ADDENDUM NO. #1

RE: ITB# 016-20 – The Banks Bid Package #6 – Lot 23 Park, Lot 23/27 Garage Signage & Security

Addendum to the Construction Documents

TY111A

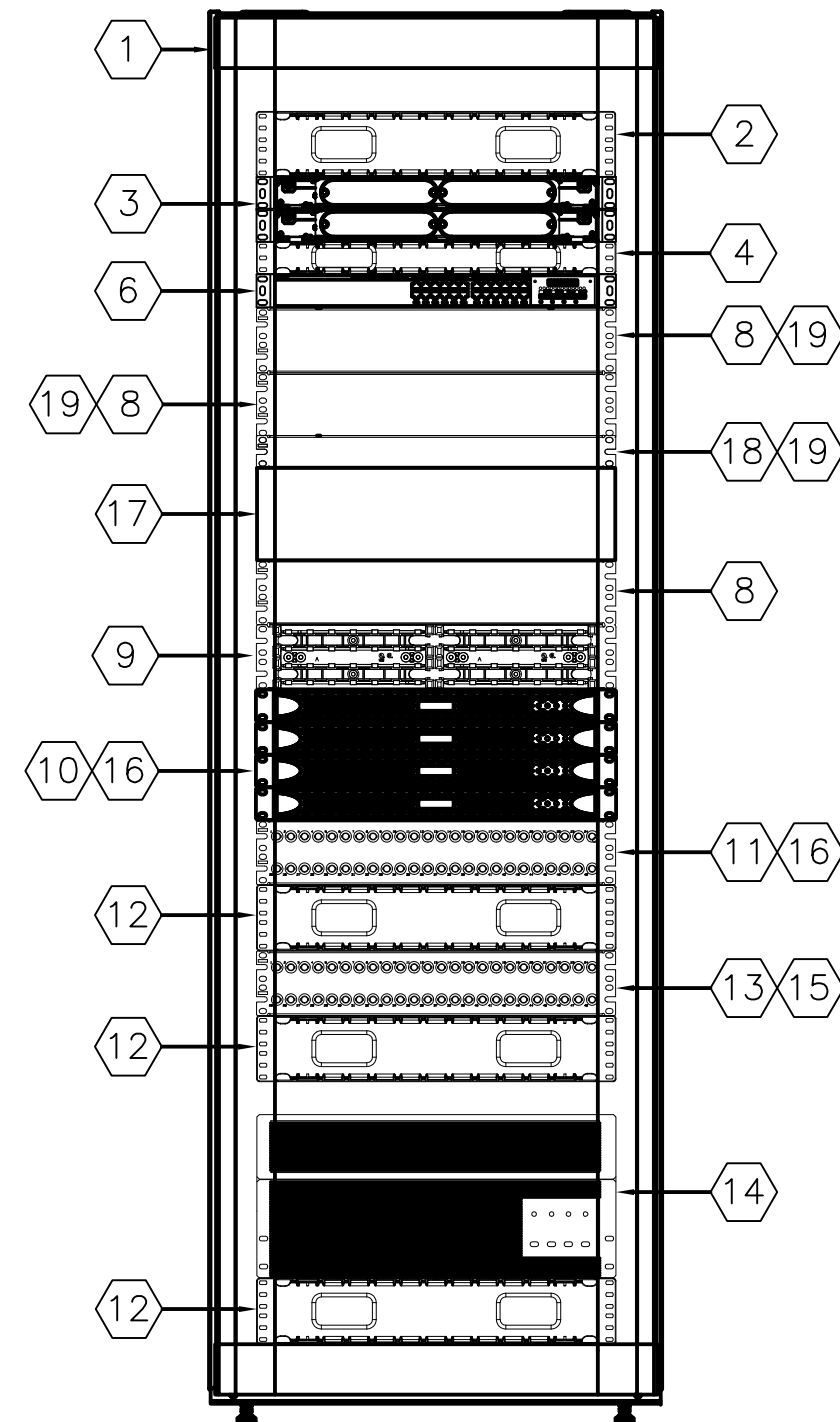
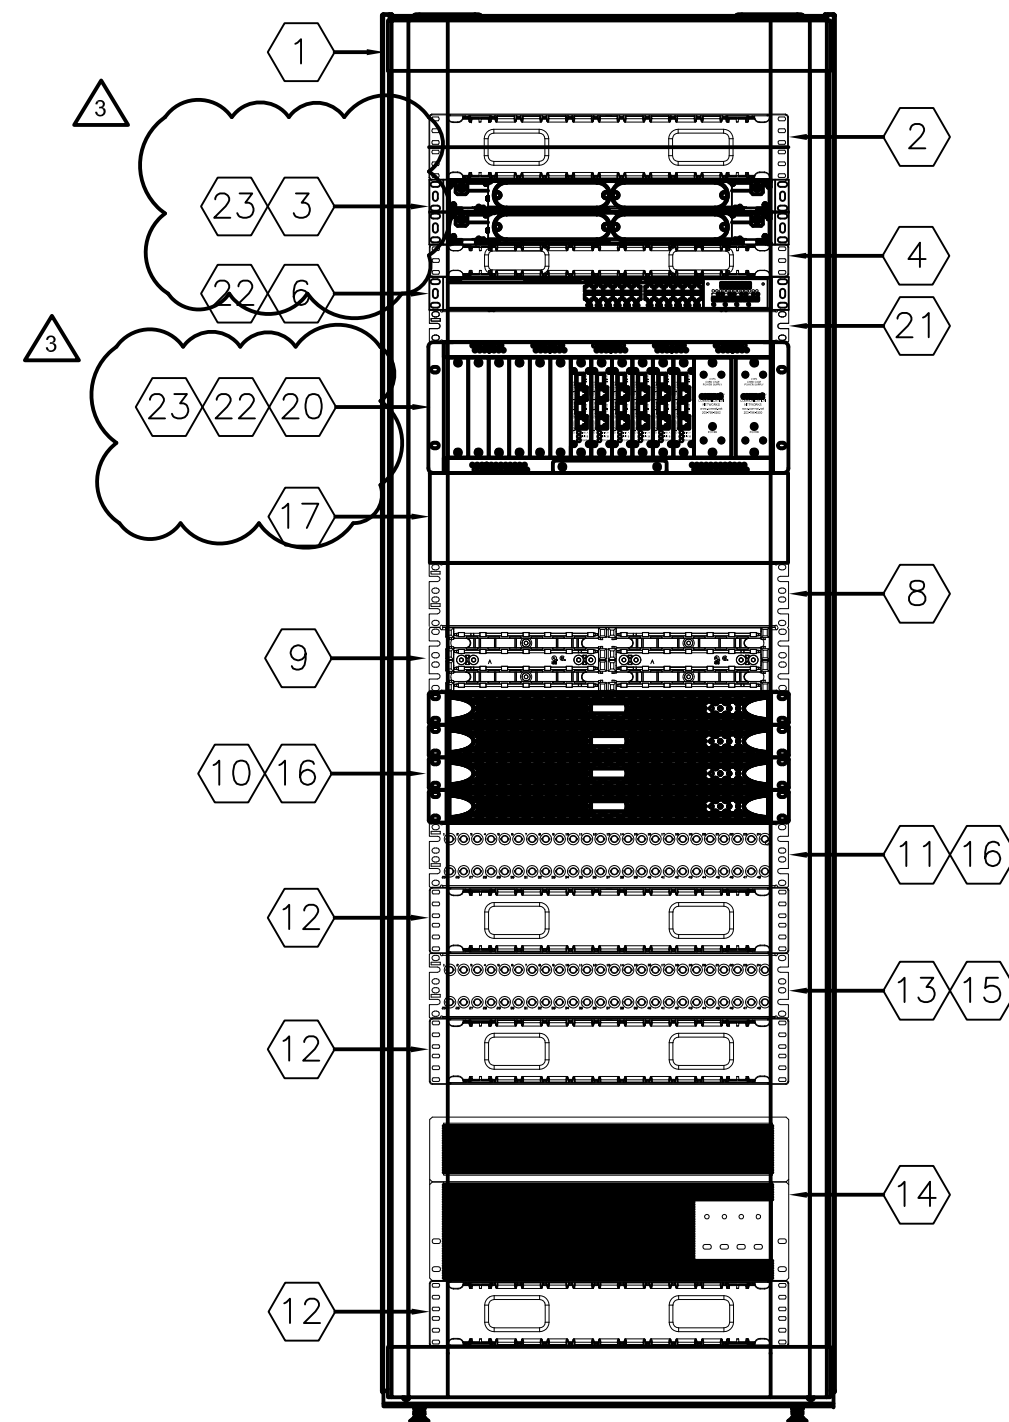
33. Drawing TY111A: (New Drawing)

- Added sheet TY111A STREET LEVEL CCTV PLAN – WEST to depict revisions to existing wireless network node BW02.
